# Guru Nanak Sikh School

planning application no. 4450/APP/2009/622

## Strategic planning application stage II referral (new powers)

**Strategic planning application stage 1 referral (new powers)**

Figure 3: Proposed building as viewed from the south in Green Belt. (Source: Integrated Design Consultants).

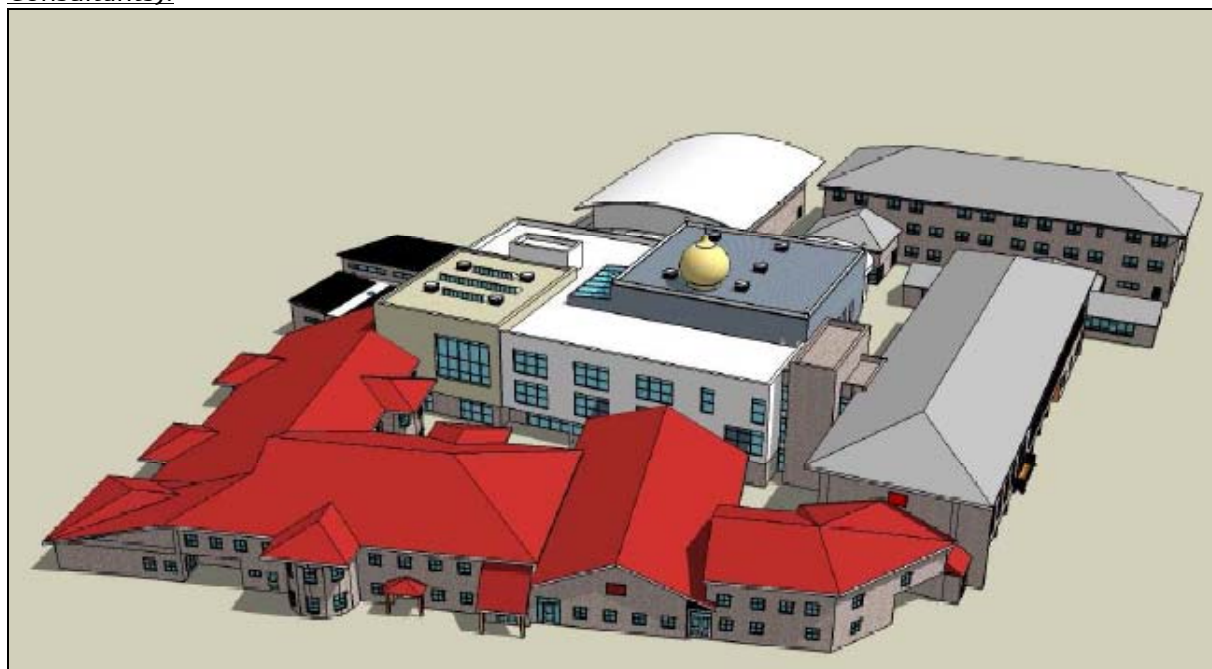
35 Given the sensitivity of the location, any proposal should be exemplar in its response to context, design quality including robust and high quality materials, inclusive design, and sustainable design and construction. The scale and overall massing of the three-storey block is

appropriate and largely shielded from view by surrounding buildings. The design is a simple, modernist rectangular cube and integrates well with the surrounding buildings. The new library will be a two-storey rotunda is located within the sheltered central courtyard, surrounded by existing buildings and is well shielded from view from all angles. The new Vocational block again is of modern design, it is positioned outside of the existing built footprint but as detailed earlier in this report, justification has been provided for its chosen location. In addition, the darker less intrusive colour scheme is appreciated given its sensitive surroundings.

36 The approach to the roofs of each of the three new buildings should be reconsidered. In accordance with London Plan Policy 4A.11 (*Living Roofs and Walls*), Green Roofs be introduced to minimise the visual impact of the building and to enhance the contribution of the scheme in terms of biodiversity.

39 The proposal does not comply with the design policies of the London Plan, particularly 4B.3 (*Enhancing the quality of the public realm*), 4A.11 (*Living Roofs and Walls*). In order to address these concerns, it is requested the applicant provides photomontages of the proposed development within the surrounding context and also incorporates green roofs for all new buildings.
